# Access Compliance Report

## Public Rights-of-Way

Intersection ID: 3683	Main Street: BROMPTON_LN	Cross Street: DAVIS_LAKE_PY	Location: SE
ADA ID: 90DBBD5CC973	Ramp Type: Perp	Initial Pass/Fail: Fail	Overall Compliance: No
Severity Score: 8.75			
Codes/Mitigation Info/Possible Solution		Field Measurements/Component Compliance

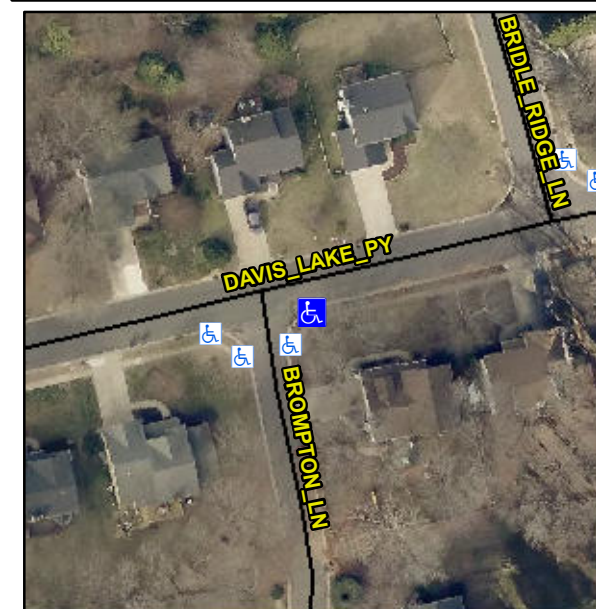
**Not Found, R304.5.1**

Compliance	Description	Data	Compliance	Description	Data
N/A	Ramp Length (in)	48.0	Yes	Ramp Slope (%)	6.7
No	Ramp Width (in)	46.5	Yes	Ramp XSlope (%)	0.2
N/A	Flare Type LT	N/A	N/A	Flare Type RT	N/A
N/A	Flare Slope LT (%)	N/A	N/A	Flare Slope RT (%)	N/A
N/A	Flare Traversable LT?	N/A	N/A	Flare Traversable RT?	N/A
N/A	Landing Length (in)	N/A	N/A	DWS Provided?	N/A
N/A	Landing Width (in)	N/A	N/A	DWS Contrast?	N/A
N/A	Landing Slope (%)	N/A	N/A	DWS Length (in)	N/A
N/A	Landing X Slope (%)	N/A	N/A	DWS Full Width?	N/A
N/A	Landing Curb? (Y/N)	N/A	N/A	DWS Offset (in)	N/A
N/A	Shared Landing?	N/A			
N/A	Gutter Ponding?	N/A	N/A	Gutter Slope (%)	N/A
N/A	Gutter Lip Ht (in)	N/A	N/A	Gutter X Slope (%)	N/A
N/A	Painted X Walk1?	No	N/A	Painted X Walk2?	N/A
	X Walk 1 Direction	To N		X Walk 2 Direction	N/A
N/A	X Walk 1 Width (in)	N/A	N/A	X Walk 2 Width (in)	N/A
	X Walk 1 Slope (%)	4.1		X Walk 2 Slope (%)	N/A
	X Walk 1 X Slope (%)	1.9		X Walk 2 X Slope (%)	N/A

**Remove & Replace Entire Ramp.**
